Re: **Second Submission Review** – Porteos Infrastructure Site Plan Phase 7
Application Number: **DA-1903-16**
Case Number: **2020-6005-00**

Second Submission Review

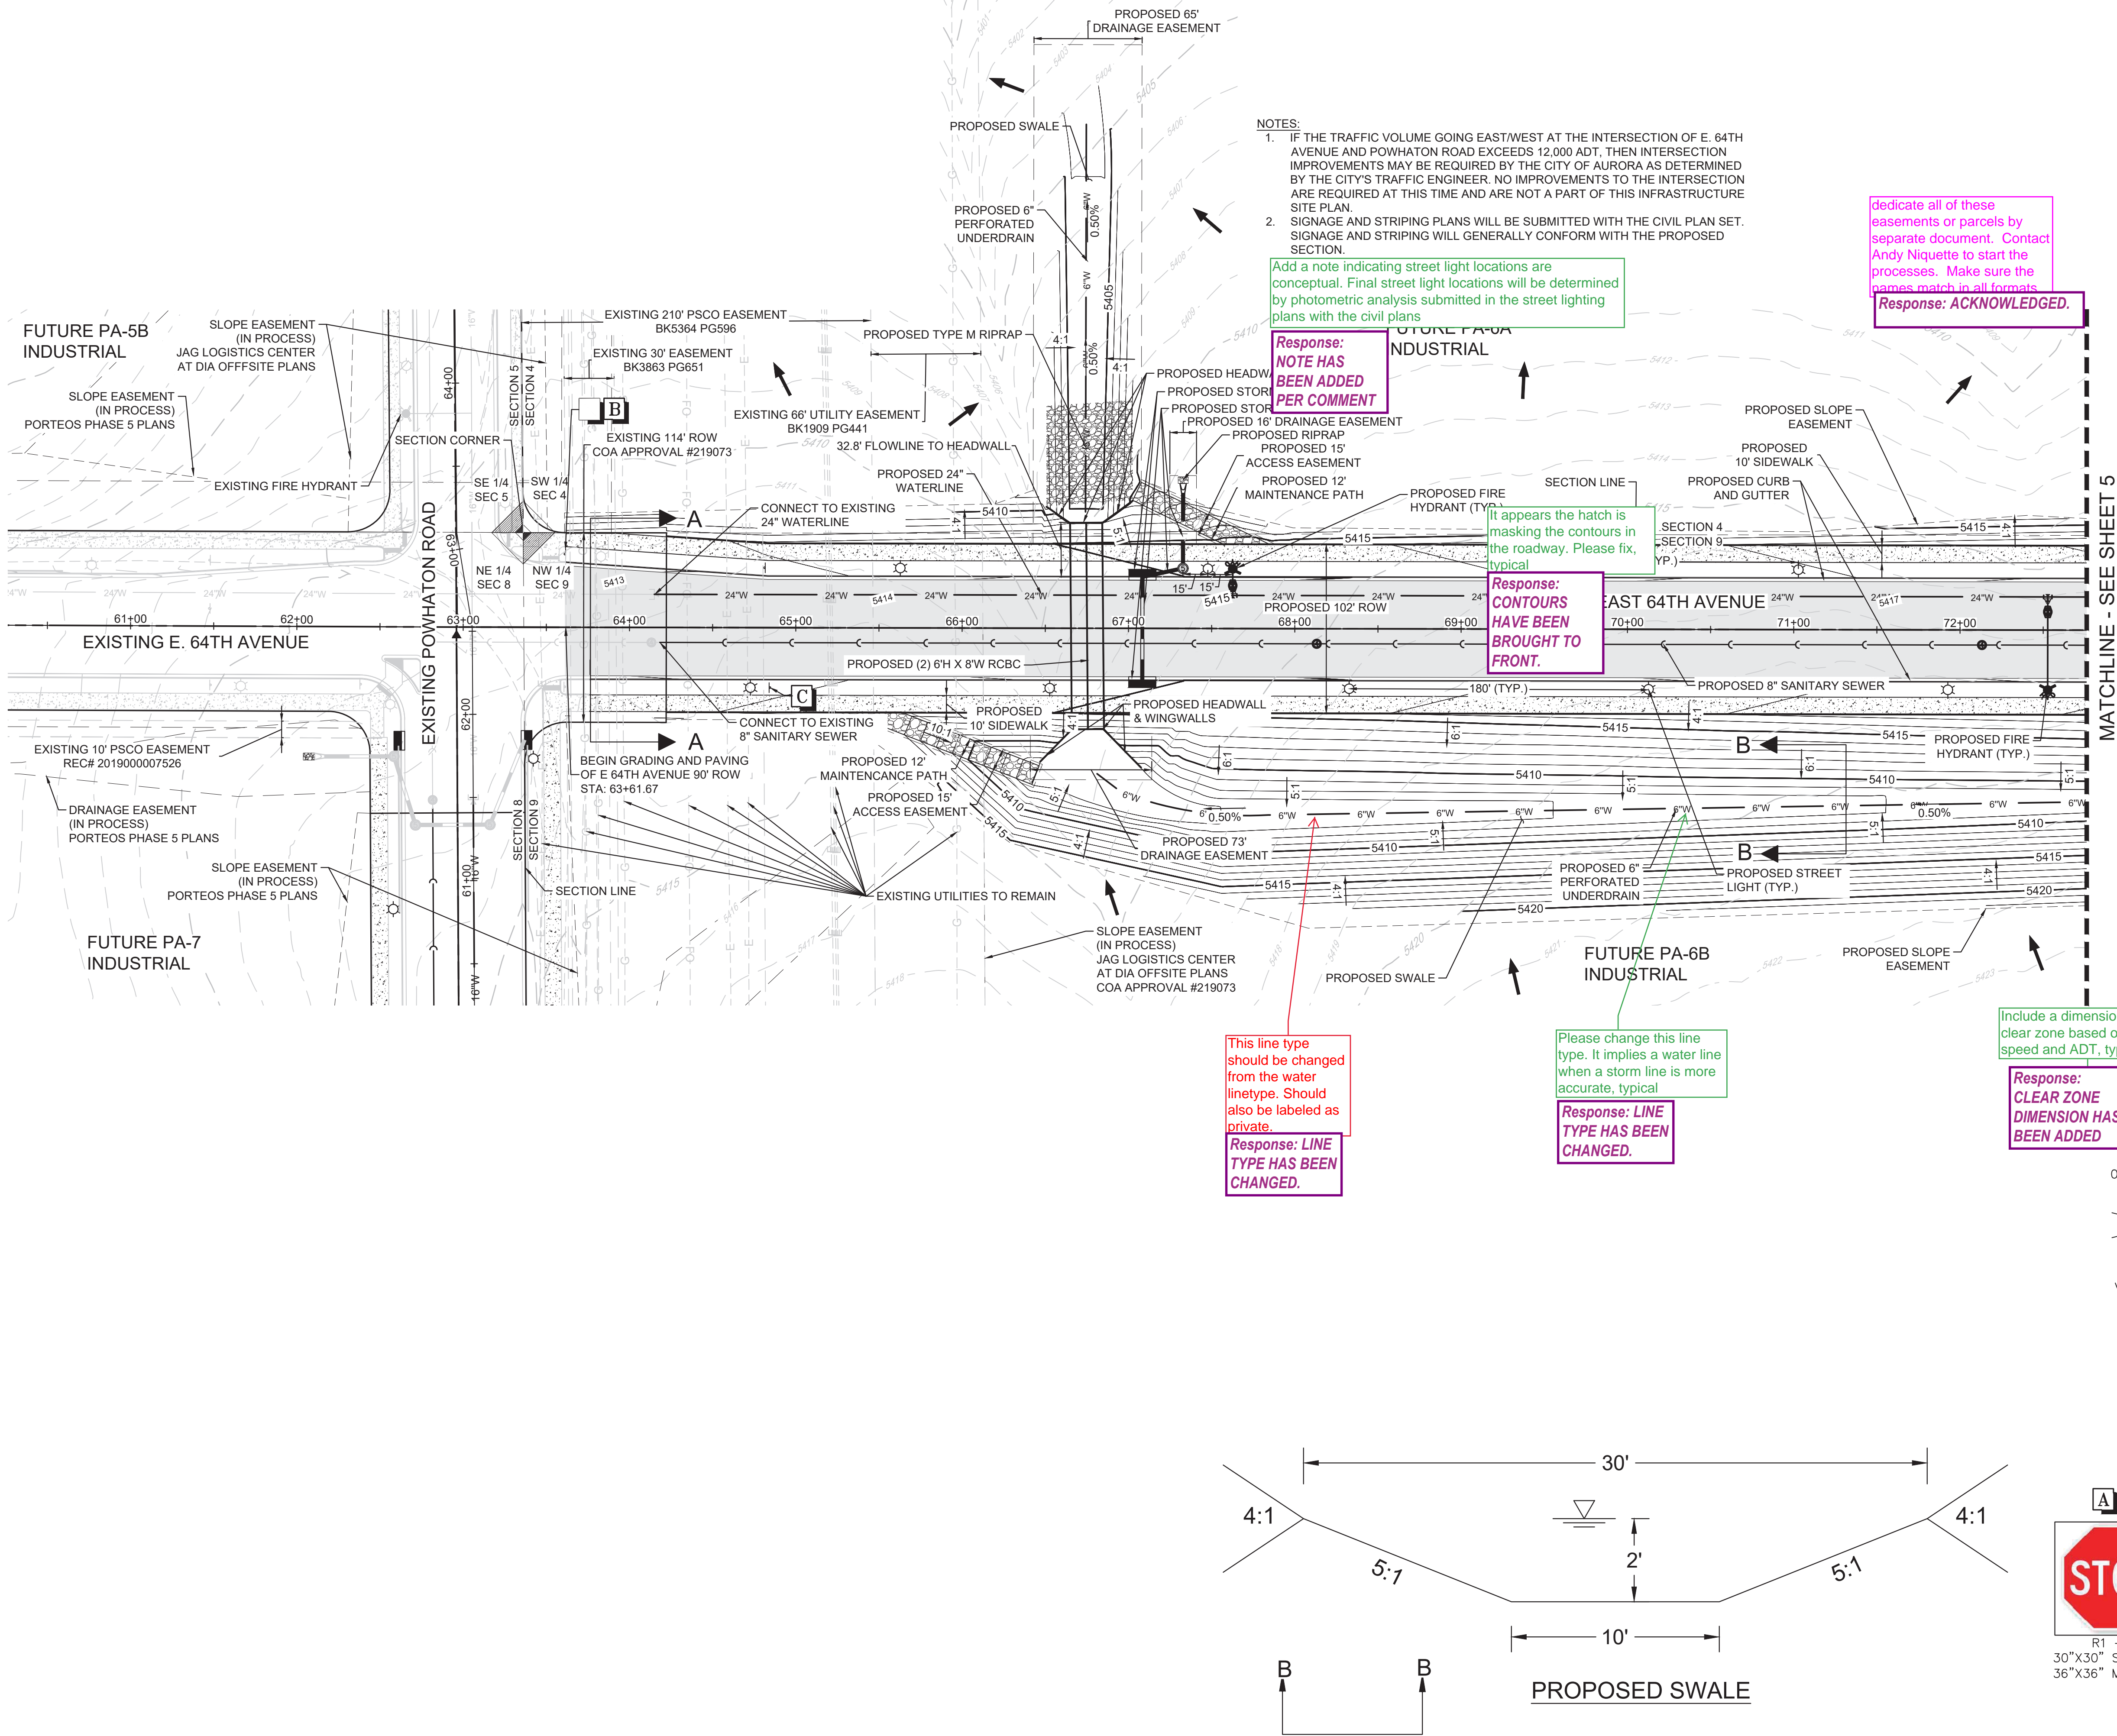
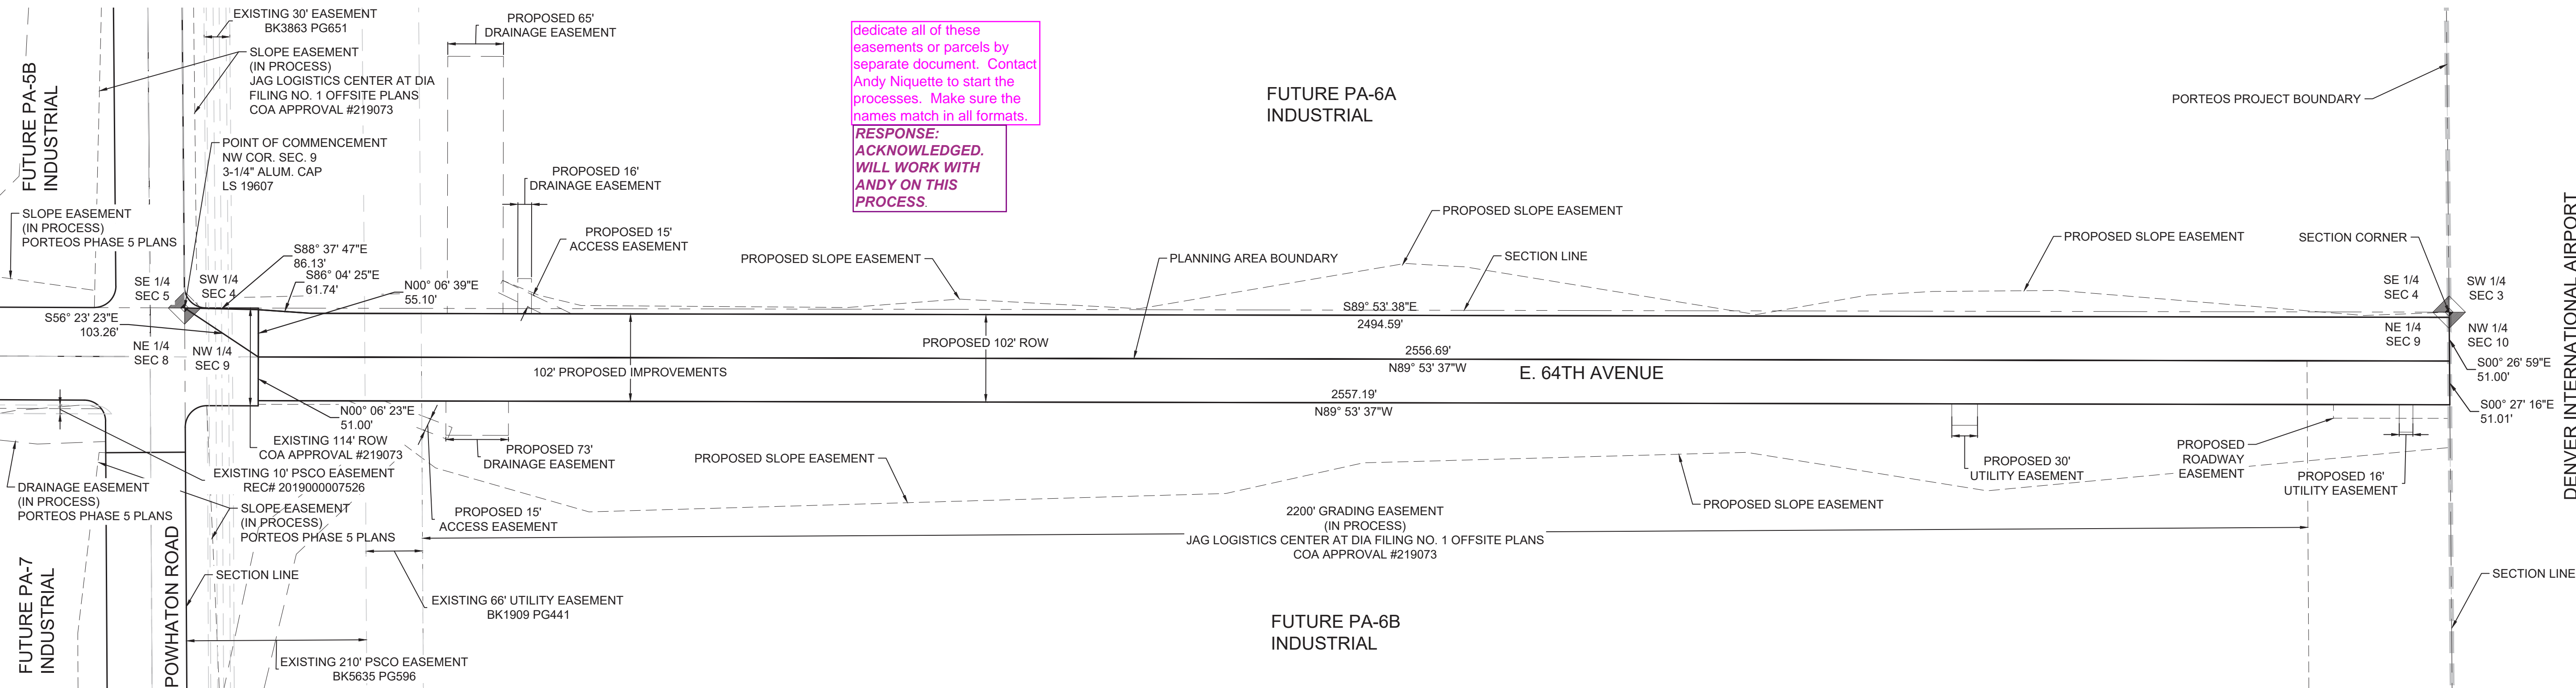
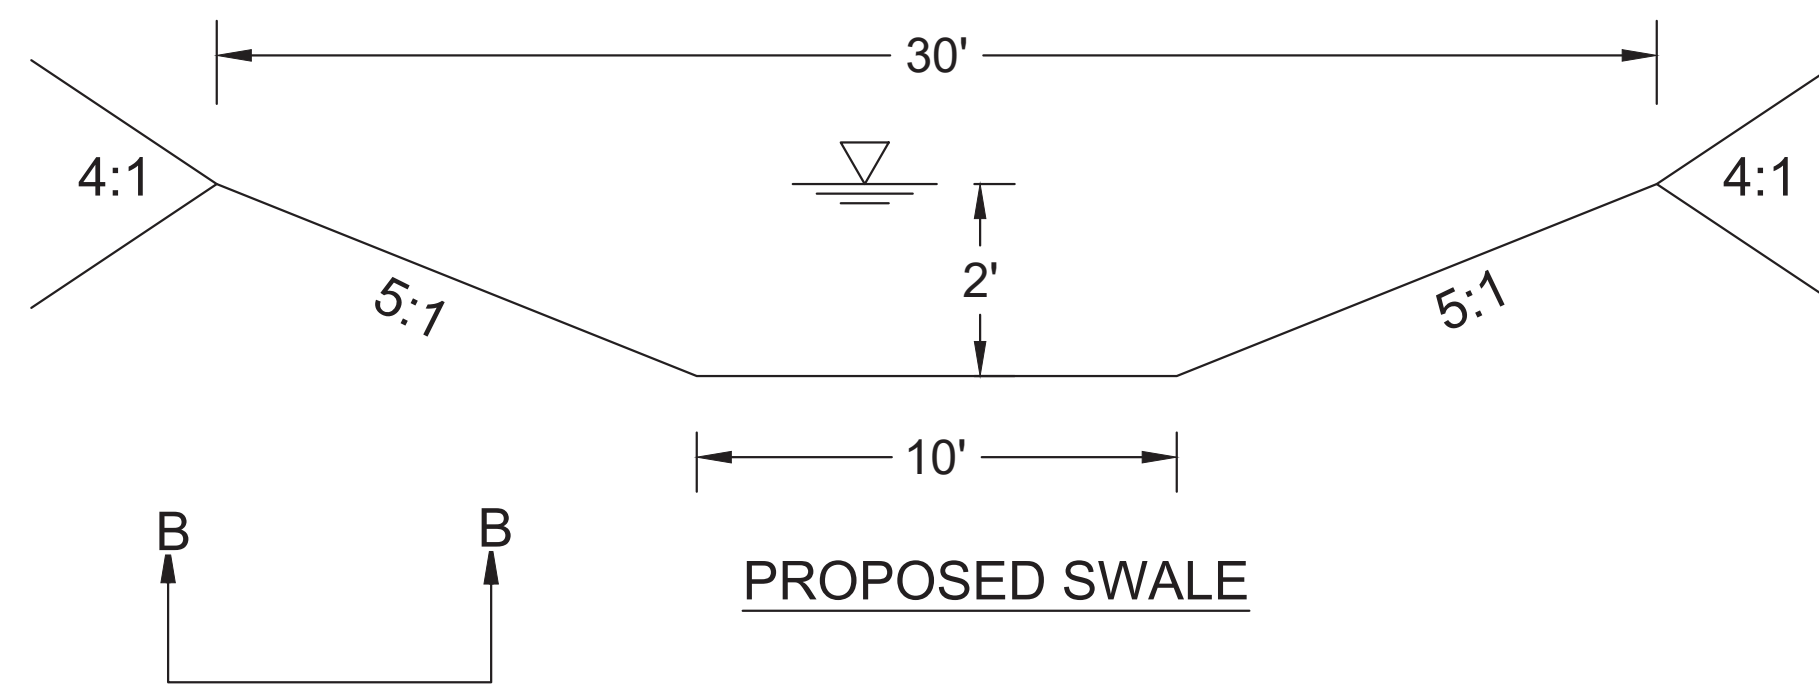
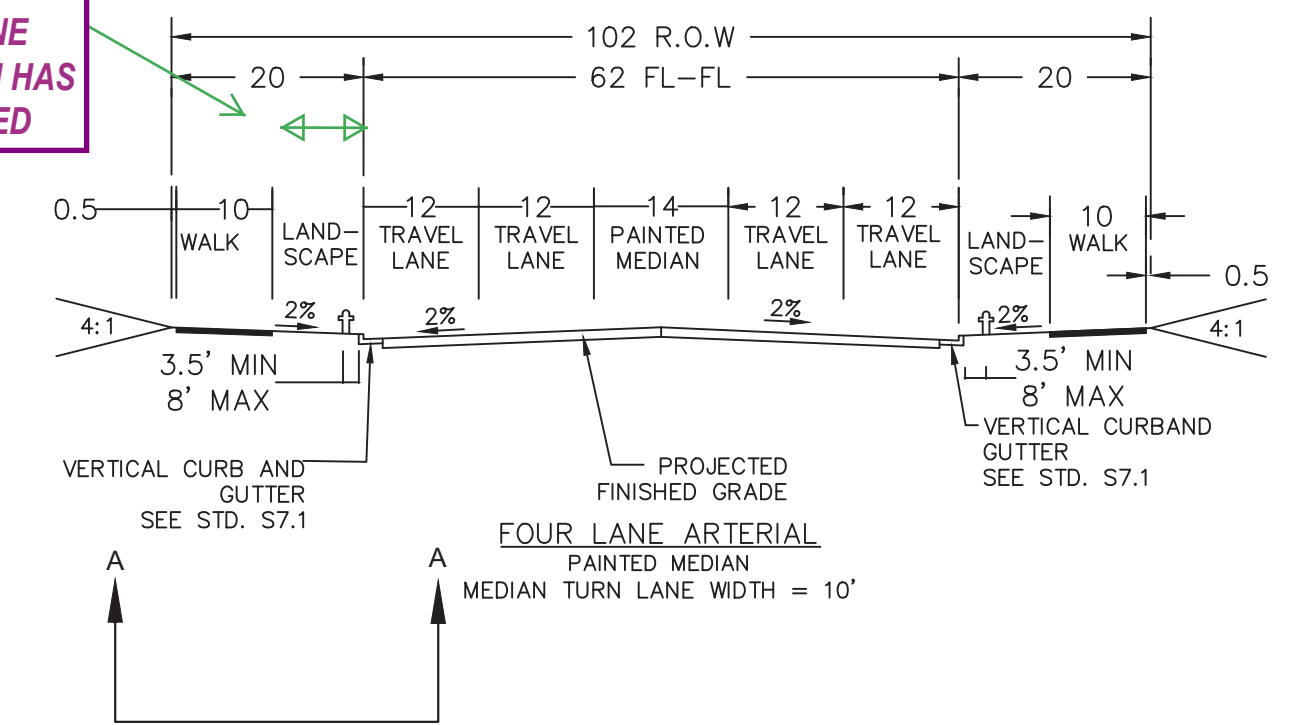
3B. Sheet 4: Include a dimension for clear zone based on design speed and ADT, typical.

3C. Sheet 4: Please change this line type. It implies a water line when a storm line is more accurate, typical.

3D. Sheet 4: It appears the hatch is masking the contours in the roadway. Please fix, typical.

3E. Sheet 4: Add a note indicating street light locations are conceptual. Final street light locations will be determined by photometric analysis submitted in the street lighting plans with the civil plans.

6A. Sheet 4: This line type should be changed from the water linetype. Should also be labeled as private.

Response: The dimension for clear zone has been added per comment.

Response: The line type has been changed per comment.

Response: The contours have been brought to front on all sheets by CVL.

Response: The note has been added per comment.

Response: This line type has been changed per comments. The line has also been labeled as "private".

PORTEOS - PHASE 7
INFRASTRUCTURE SITE PLAN
PLANT SCHEDULE

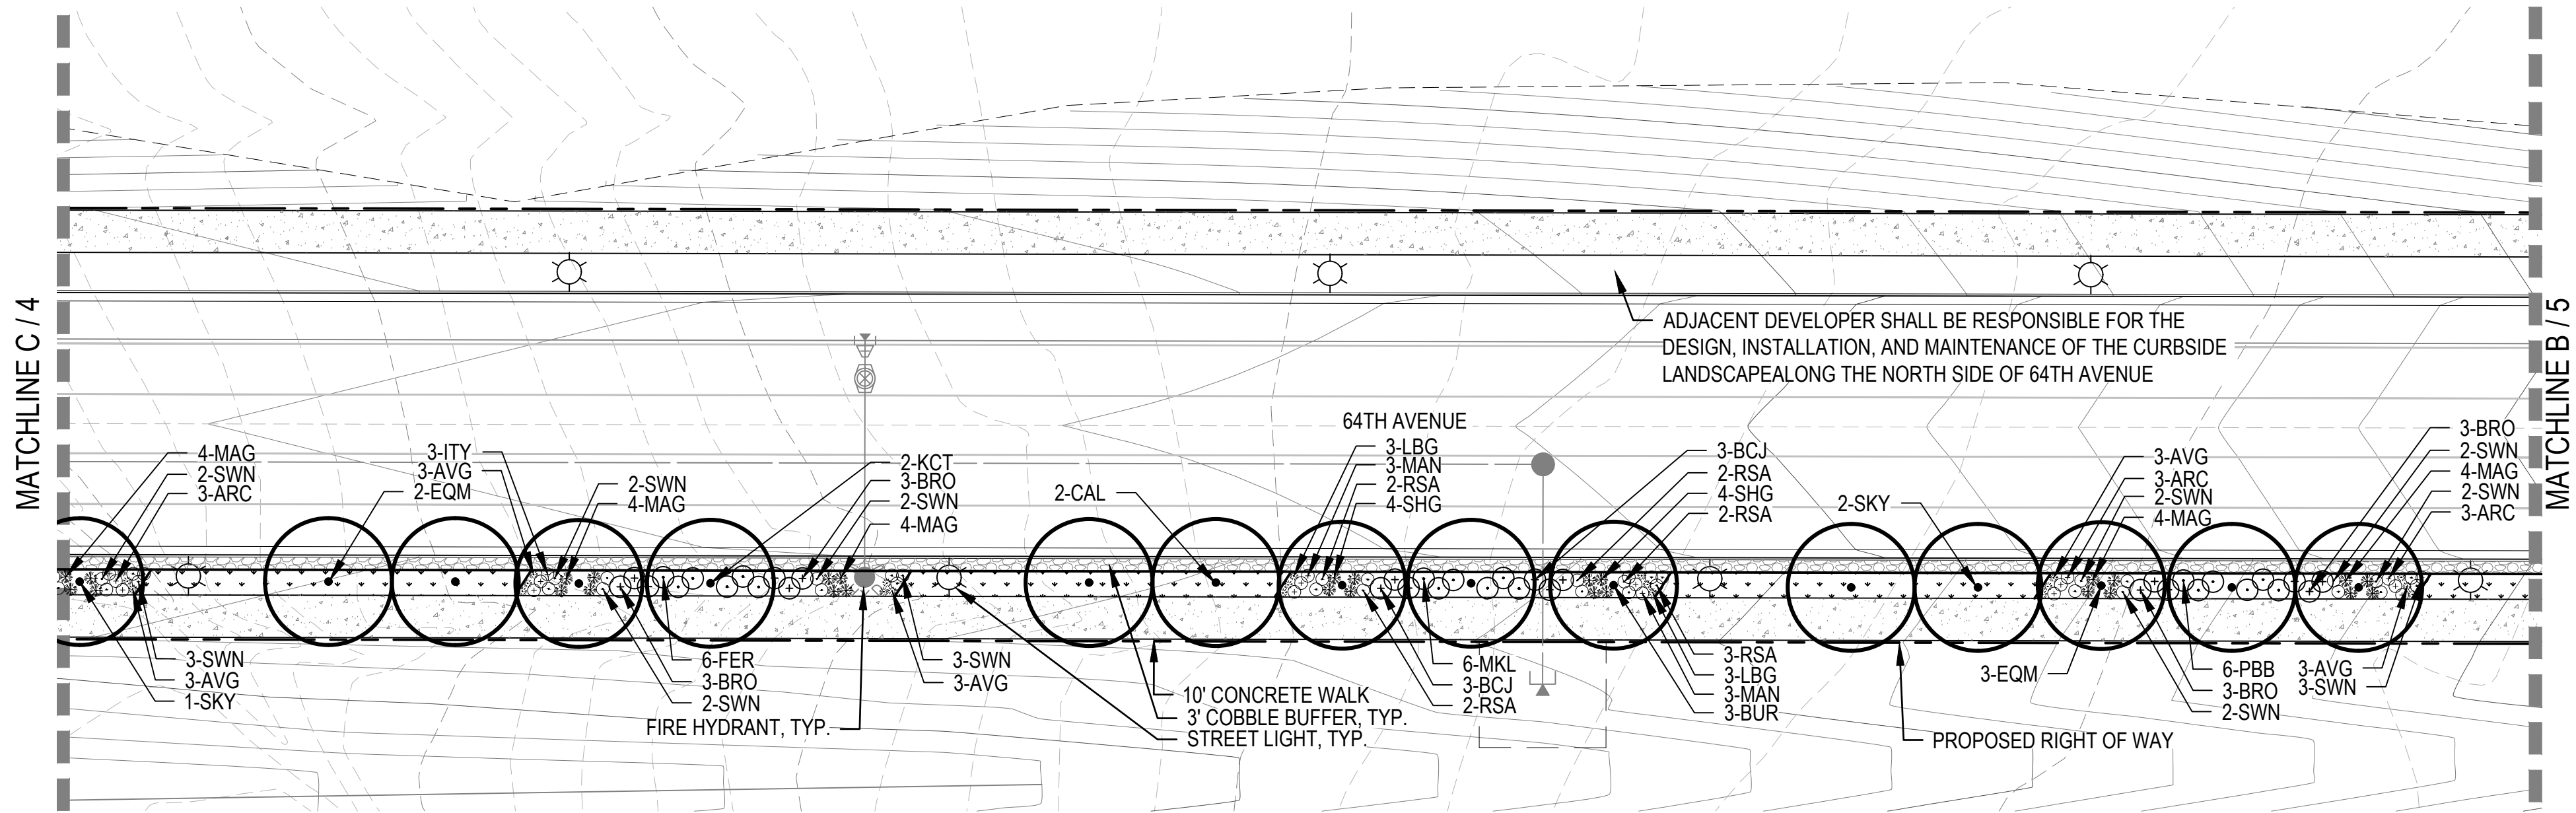
2C. Sheet 7: See highlighted plantings-Although xeric, this plant because of its thorny nature, is not permitted in the curbside landscape.

2D. Sheet 7: Modify botanical name.

Wrong botanical name

Although xeric, this plant because of it's thorny nature, is not permitted in the curbside landscape.

Response: The Ivory Tower Yucca has been removed from the plant list.

Response: The botanical name of the Bur Oak has been corrected.

Response: Botanical name has been updated to be correct.

Response: Ivory tower Yucca has been removed from the plant list.
